Parcels 14 & 15

CV Properties

Proposal Summary & Design Review Panel Comments

I-195 Redevelopment District Commission Meeting
July 24, 2024

Comments on base materiality and lobby entrance

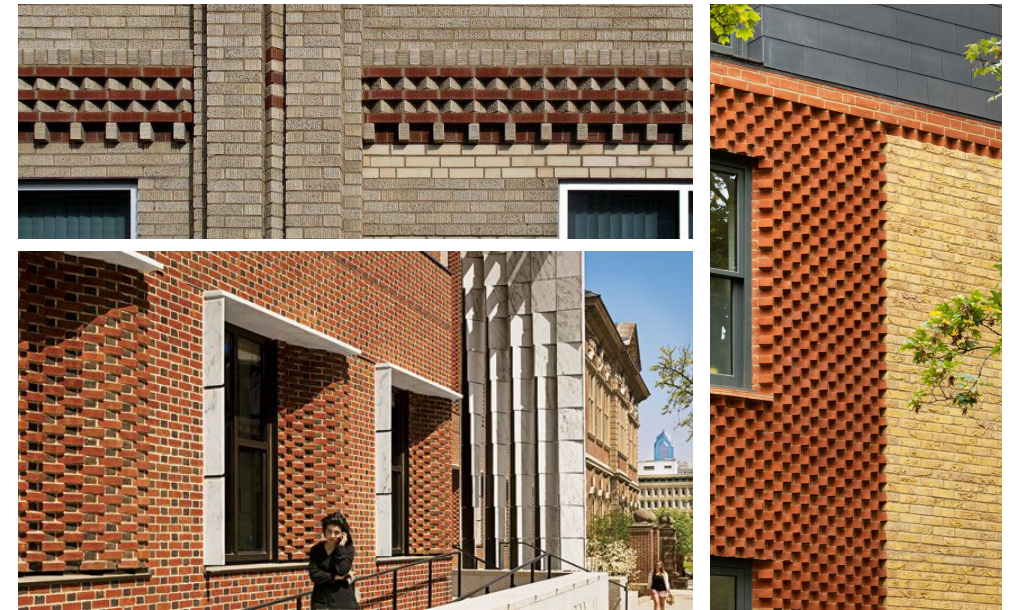
Use full dimensional brick to allow for additional brick details that can add texture and shadow. These might include a corbelled or dog tooth pattern in lieu of a flush stacked bond in the band between the first and second floor windows.

Example of brick return conditions

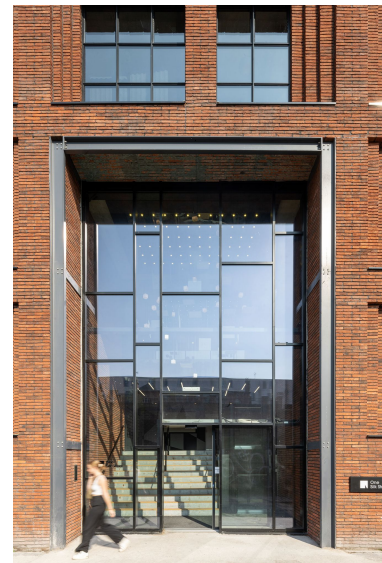
Push back the full-height transom window above the lobby entrance vestibules on both sides of the building by at least 30 inches so brick can be returned the full depth of the step back. This will make the entrance more legible, reinforce the through-building connection to the future mid-block plaza, and make the brick base look more substantial.

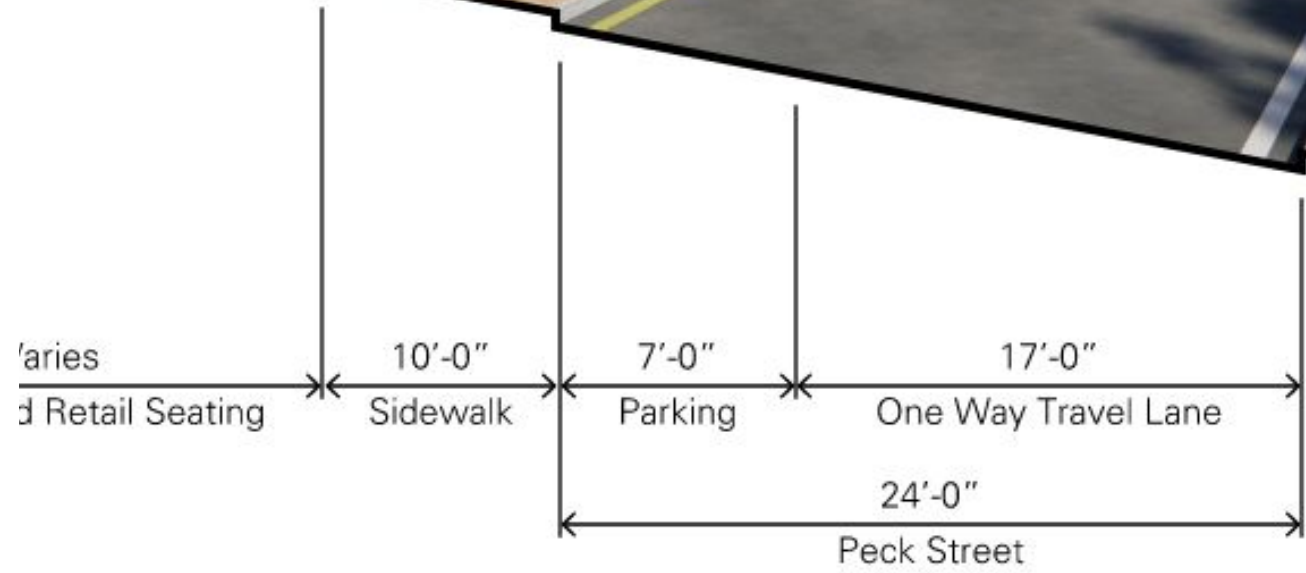
Make retail space more attractive to restaurant tenant by adding several features to core-and-shell scope

1. An entrance vestibule at the top of the ramp from Peck Street that partly extends into the plaza and partly pushes into the interior space and clearly signals that it is the front door of a restaurant.
2. French doors, accordion doors, or other shopfront treatment that allows for an indoor/outdoor dining experience when the weather is nice. At a minimum, this treatment should be added to the shop front module facing the park that is closest to the river.

Recommended Landscape & Hardscape Adjustments along Peck St

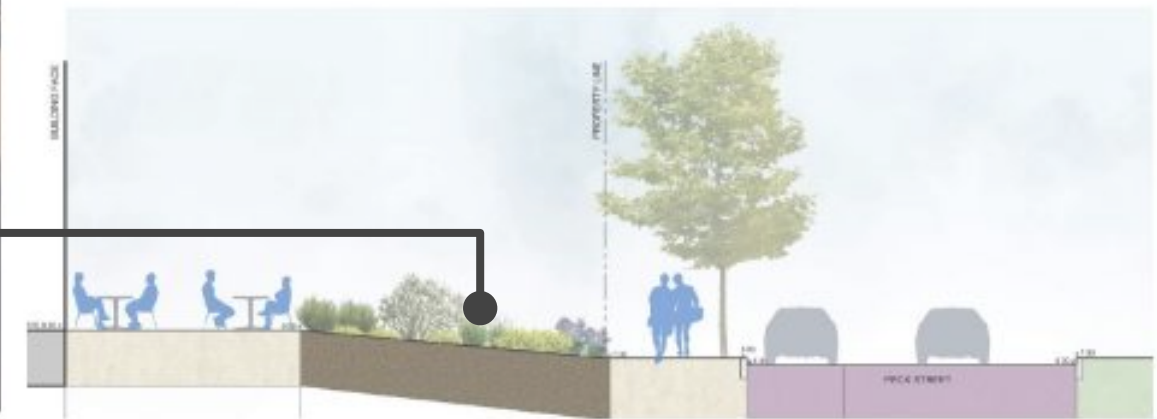
Add a wide flight of stairs that are on axis with the front doors so there is a direct connection between the lobby and the logical pick-up/drop-off location.

Add an accessible route from the same curbside locations.

Make other ramps and slopes that lead to the entrance wider and more intuitive relative to pedestrian desire lines.

Plantings between Restaurant Terrace and Sidewalk

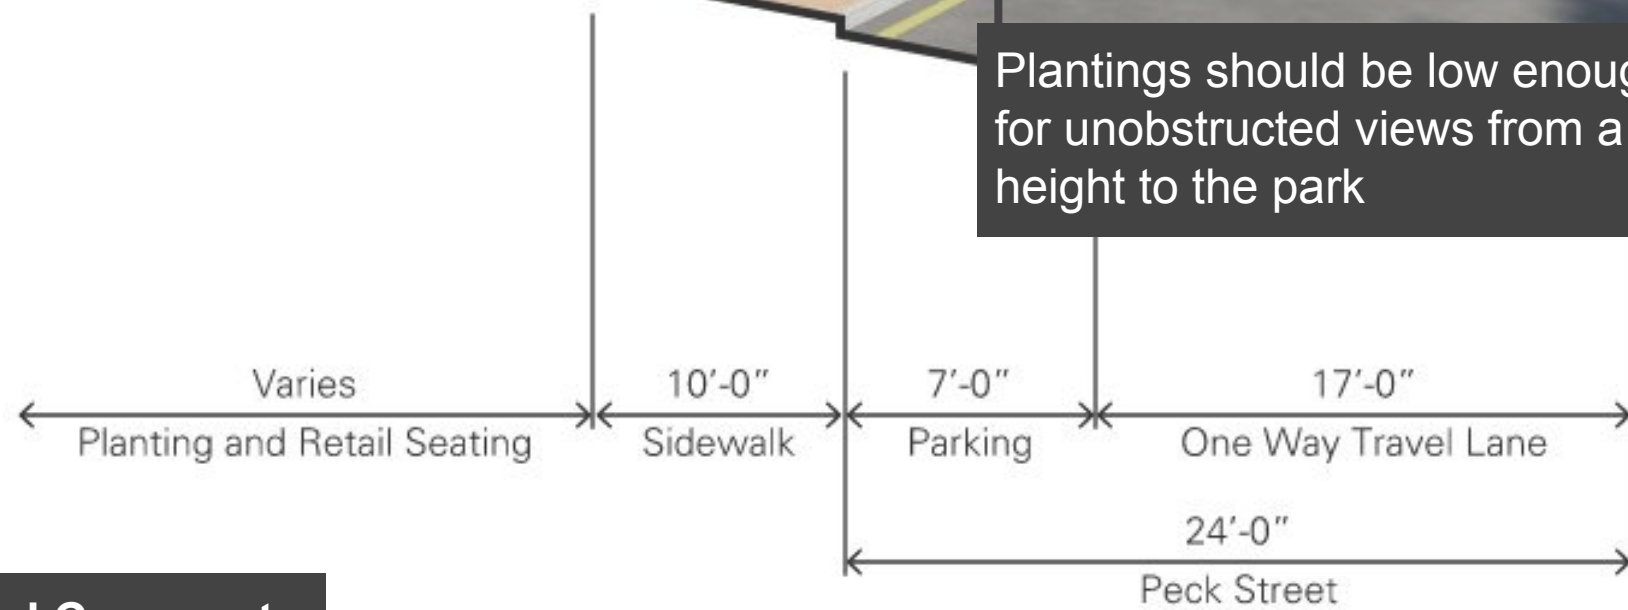
Plantings should be low enough to allow for unobstructed views from a seated height to the park
